# ST. PETERSBURG COLLEGE

## PALLADIUM BUILDING

### ADDENDUM NO. 1

MATRIX PROJECT NO. 16-0610

**A3.2**

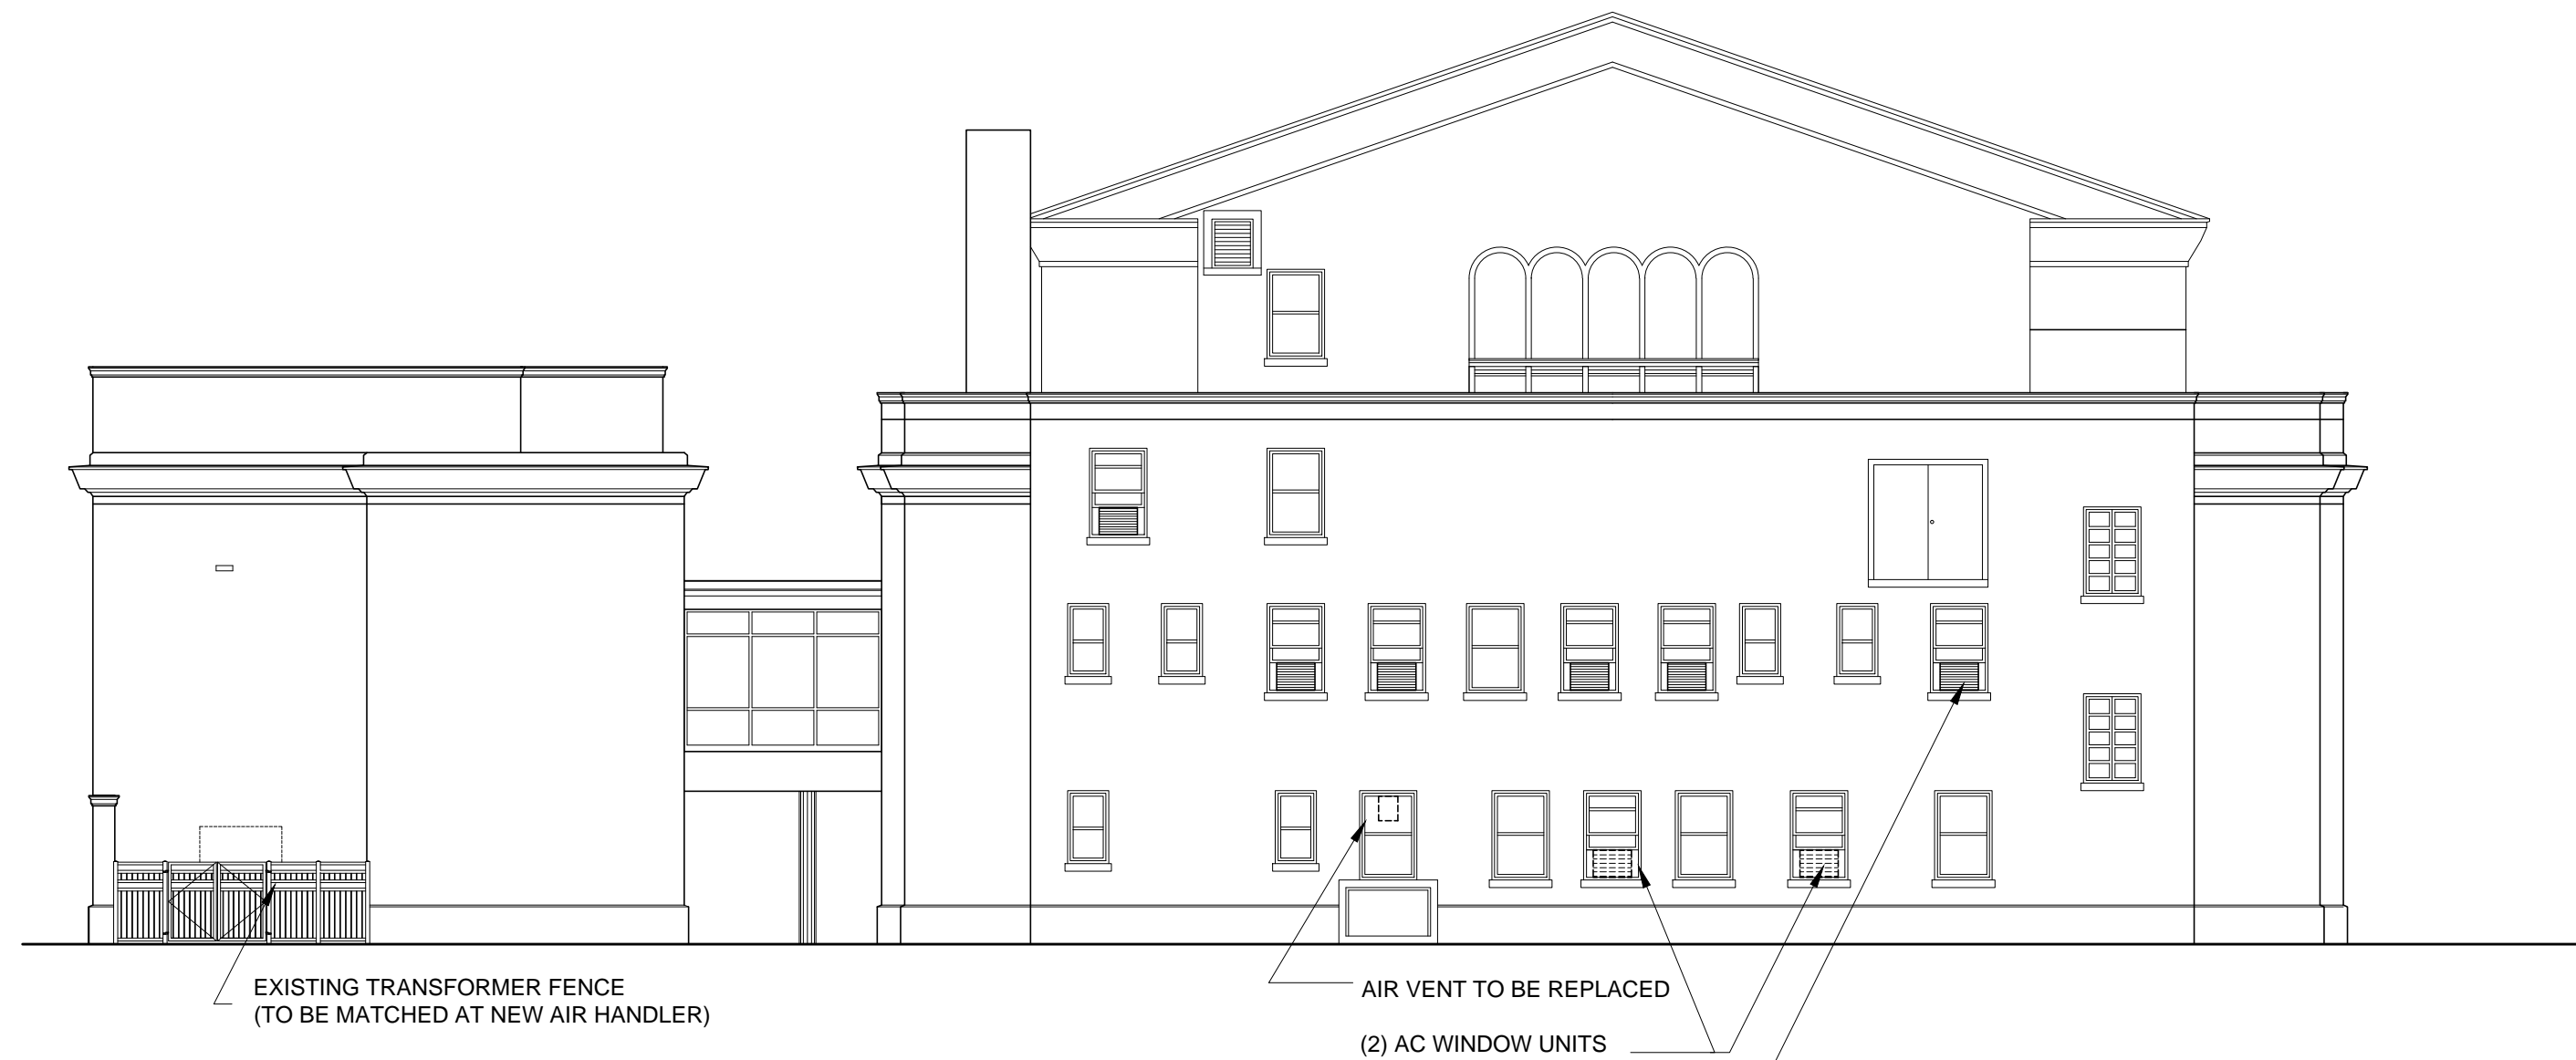
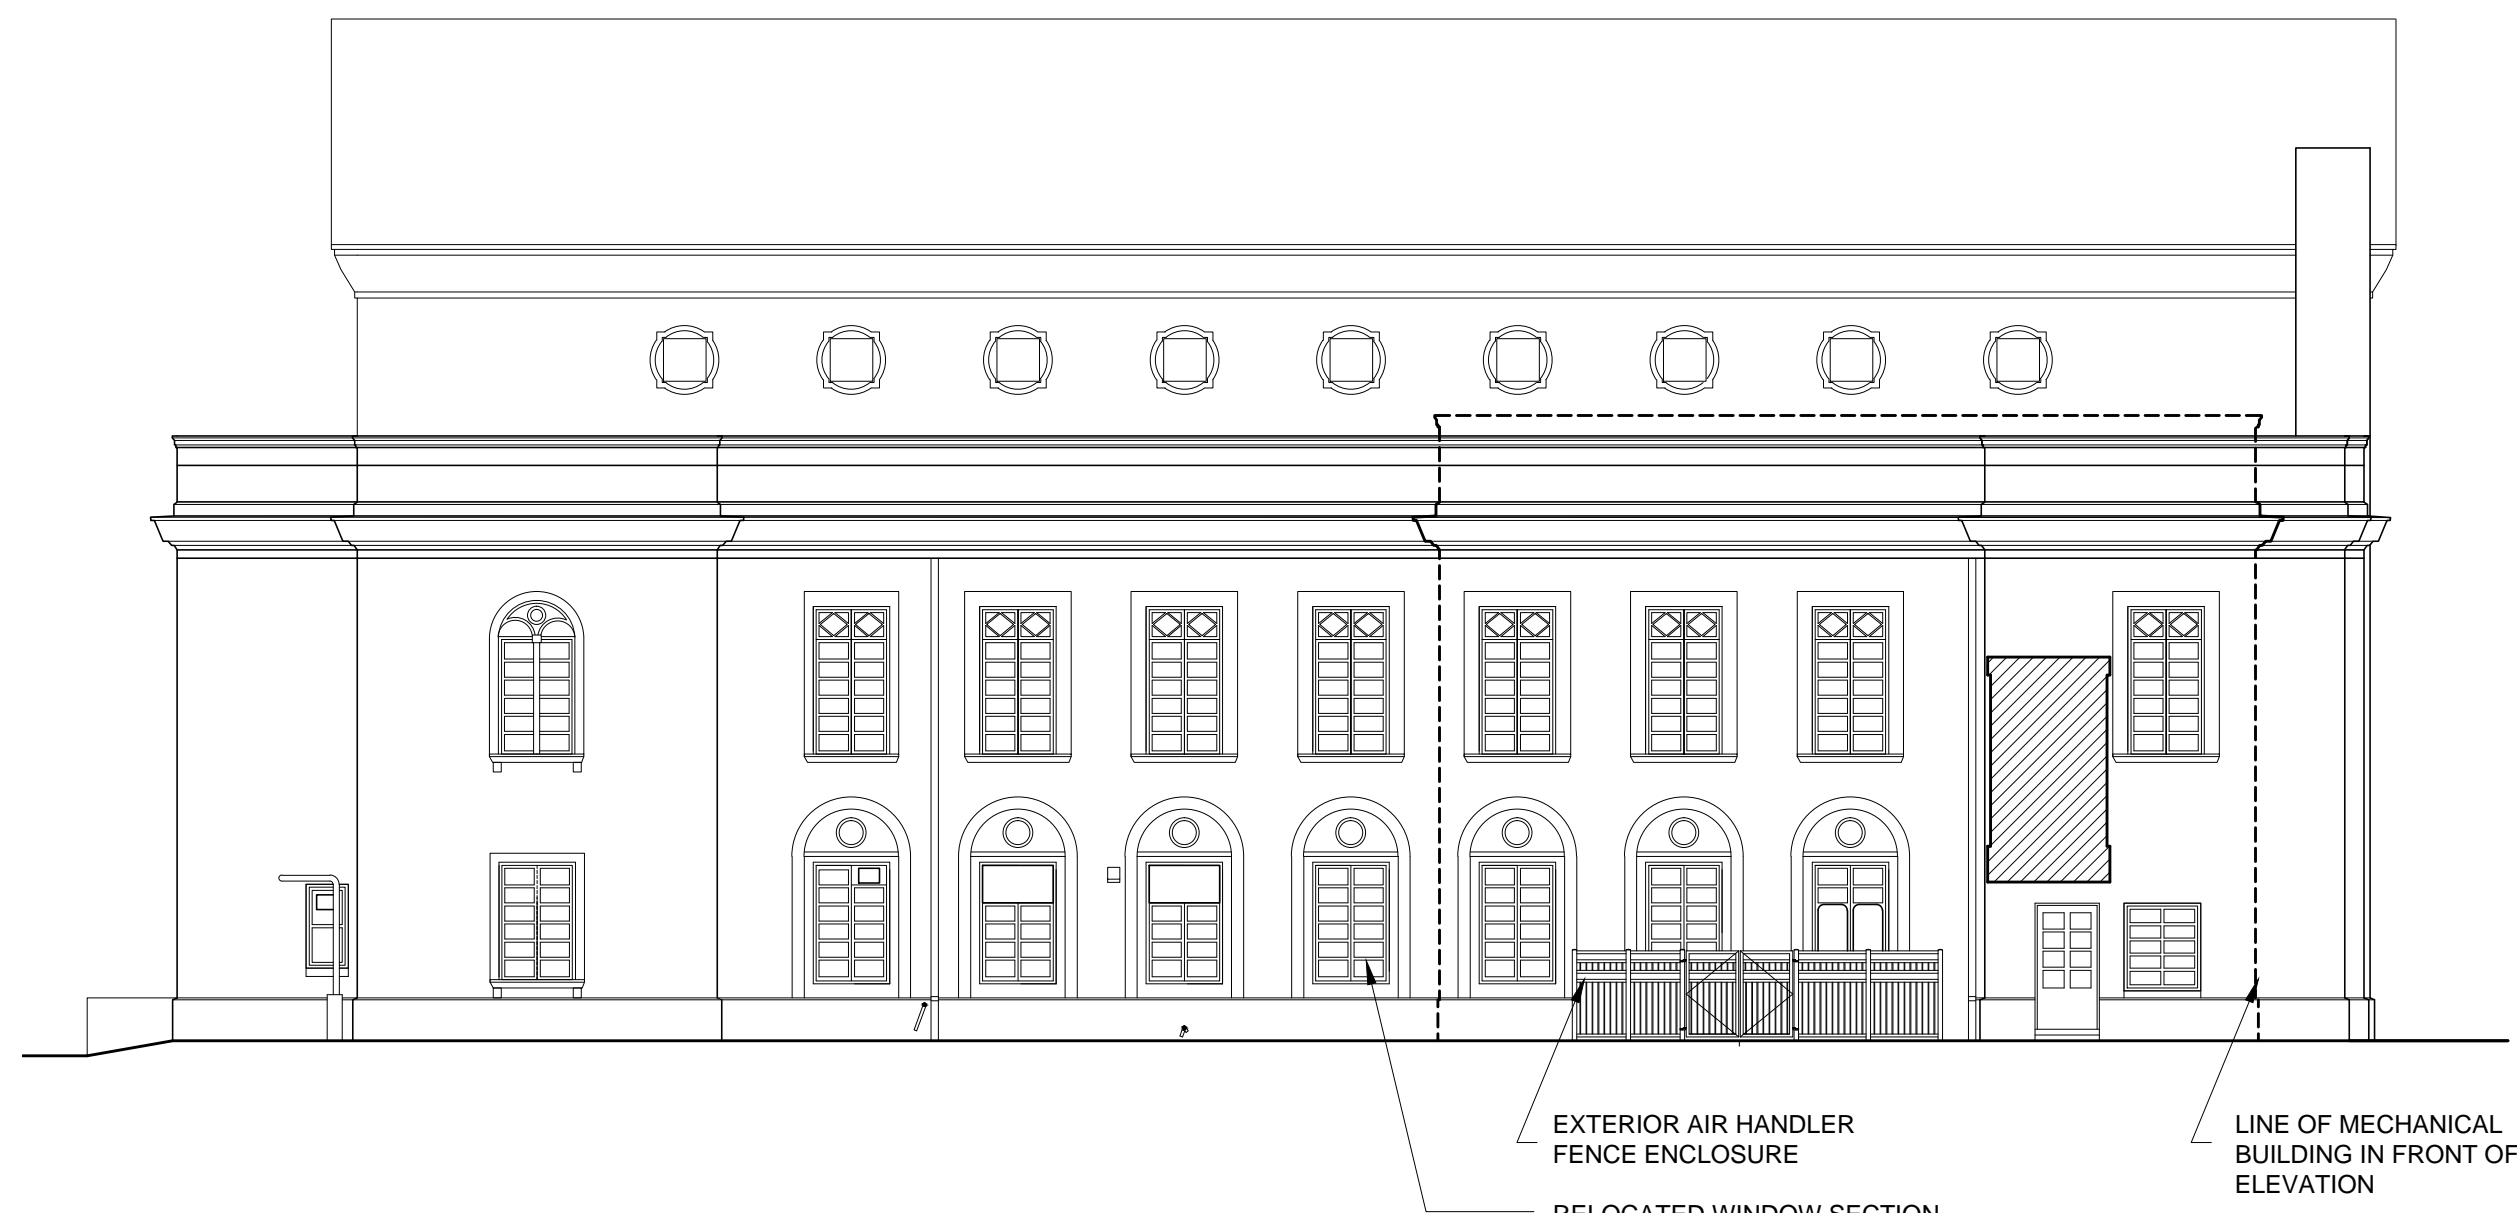
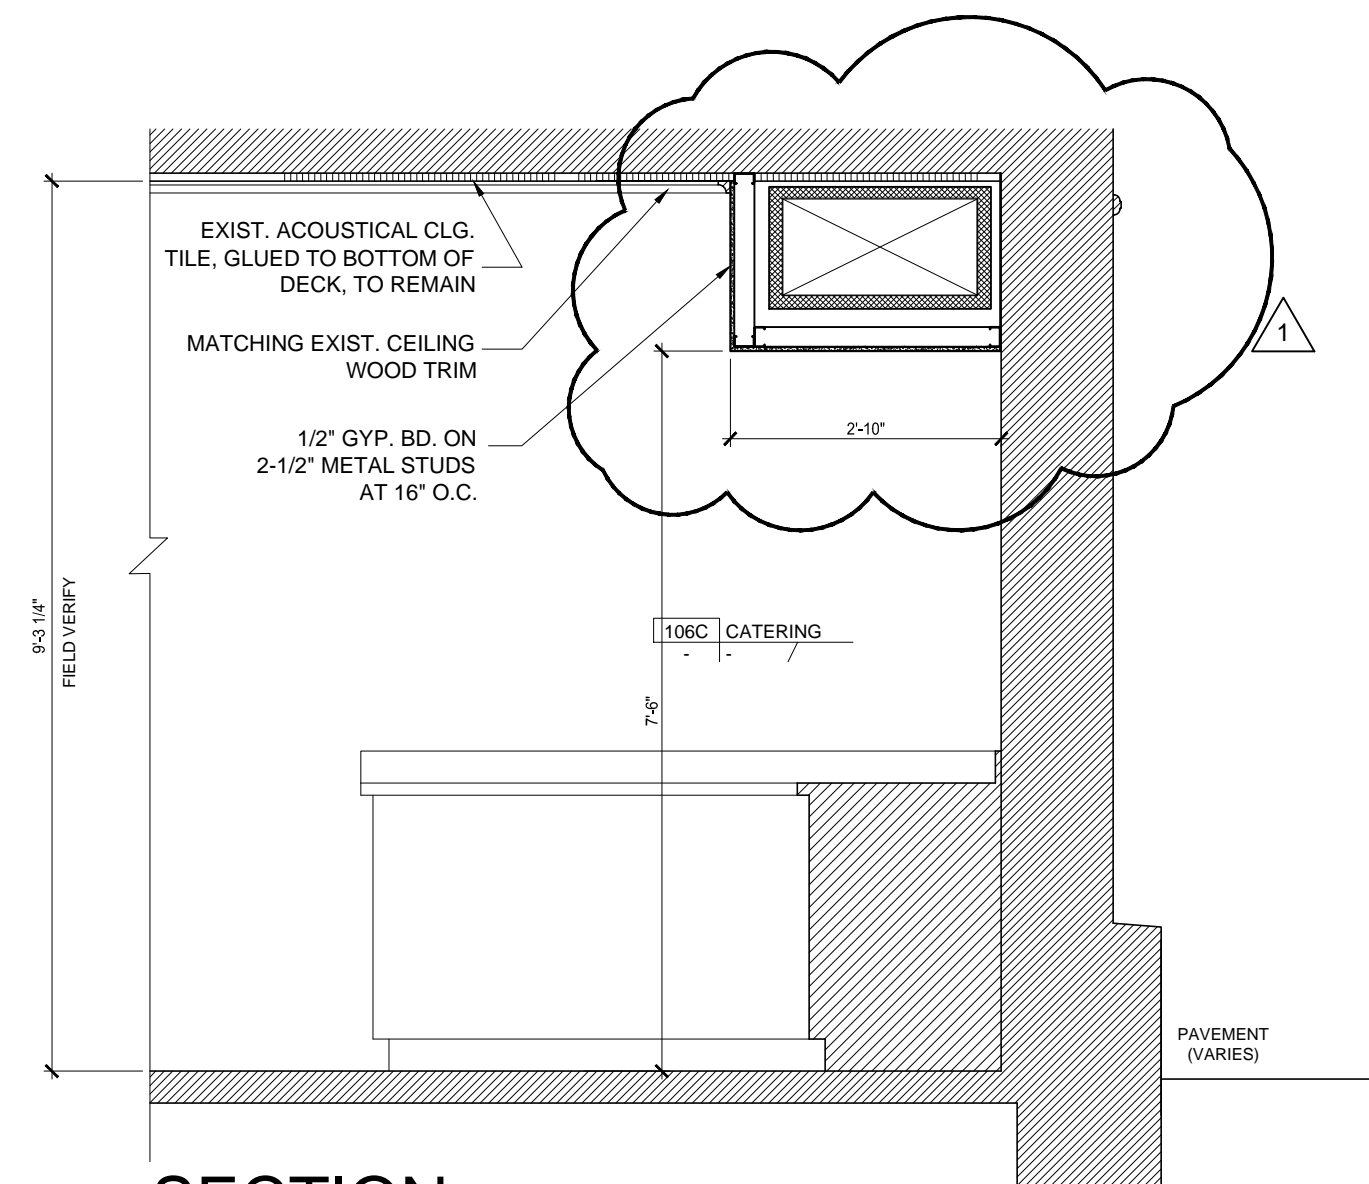
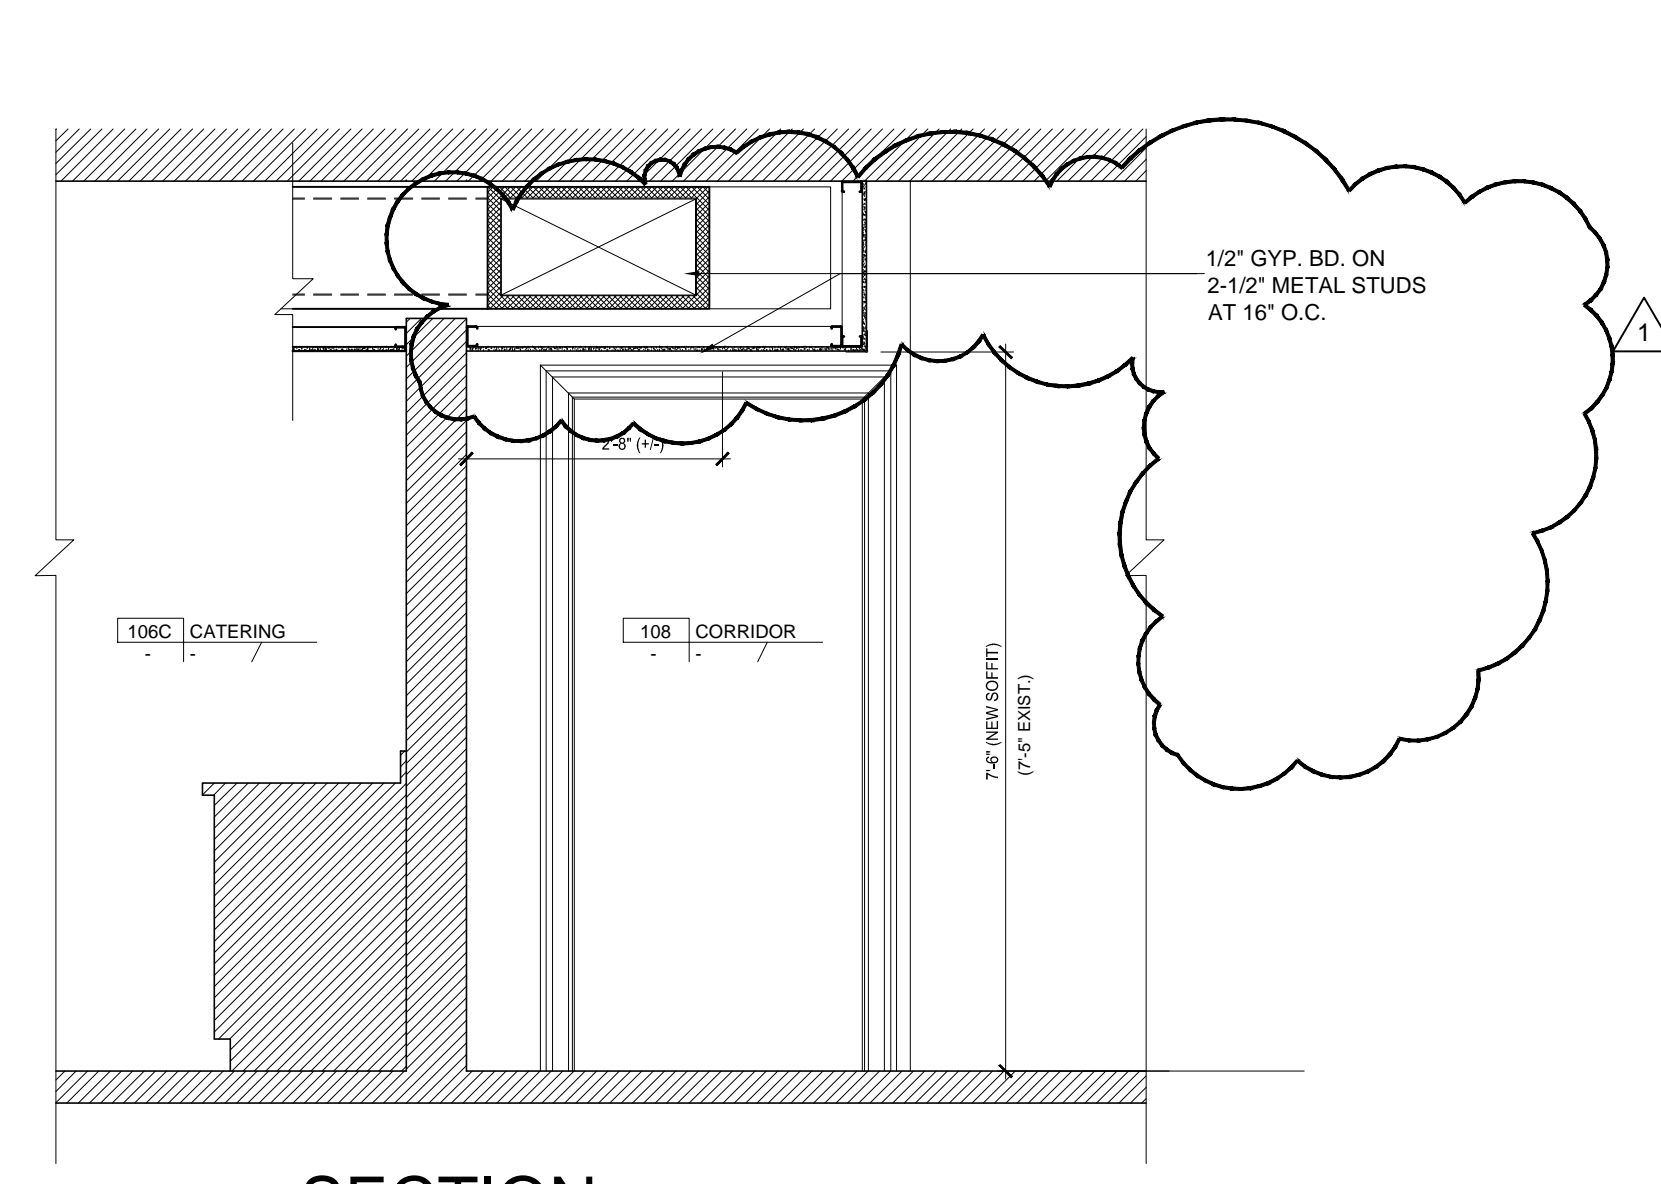
- Item 1. Drawing A3.2, Building Sections and Details
- CLARIFIED the soffit dimensions and materials as shown.
- Item 2. A3.3, Ceiling Plans and Mechanical Enclosure.
- CLARIFIED the wall trim requirements in the corridor.
  - CLARIFIED the soffit dimensions as shown.
  - MODIFIED the locations of the existing bike racks as shown.
  - CLARIFIED patching scope and locations for demolished air devices.
